Fresno Unified School District

ADDENDUM NO. 1
INFORMAL BID NO. 1421-40285
SUNNYSIDE MIDDLE SCHOOL NEW MARQUEE SIGN

**FRESNO UNIFIED SCHOOL DISTRICT
SCOPE OF WORK**

G-008

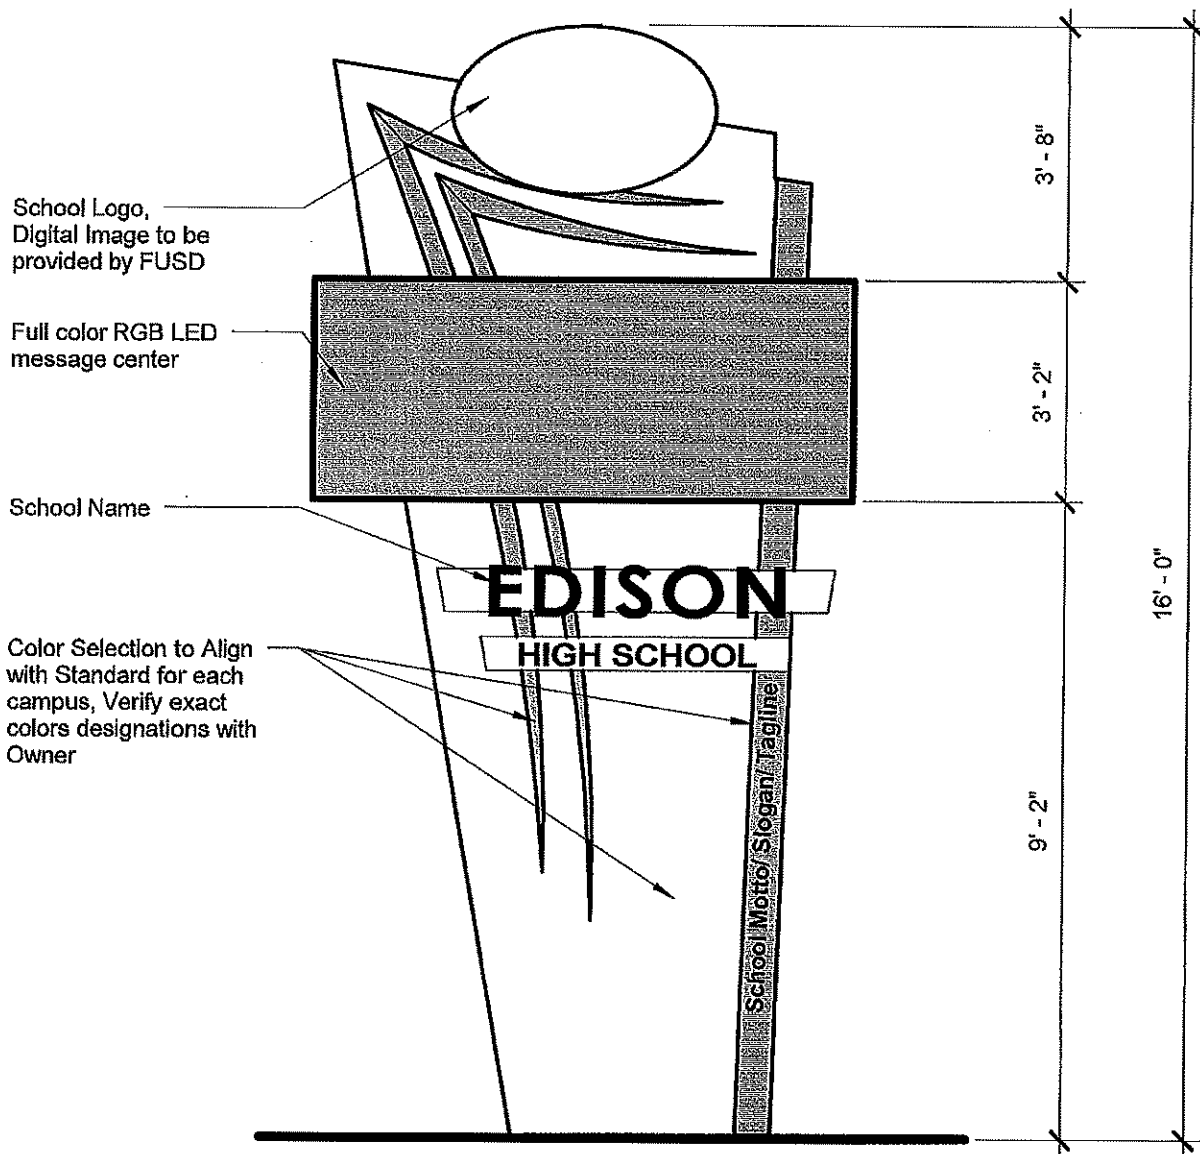
Add: Incorporate Design Guide

Attached is the Design Guide drawing for your reference.

Install 1 new double sided LED Message Center Pylon Sign as manufactured by Fresno Neon . Exterior fabricated out of 0.080 sheet aluminum with a square tube aluminum face. Exterior will have a smooth satin acrylic polyurethane paint finish with a clear coat finish. Accents & underscore to be routed out of 1" Komacel material with painted background and lettering. Logo & School Name will be internally illuminated black pan channels with 1/2" acrylic bleed edge faces decorated with (3M) vinyl films. Full color RGB LED message center will be painted satin black with finished ends & perforated bottom cover with exterior mounted temperature probe & clear cover. Display will have a direct bury and concrete footing and mow strip. Fabrication, electrical & installation will be done according to DSA & UL requirements.
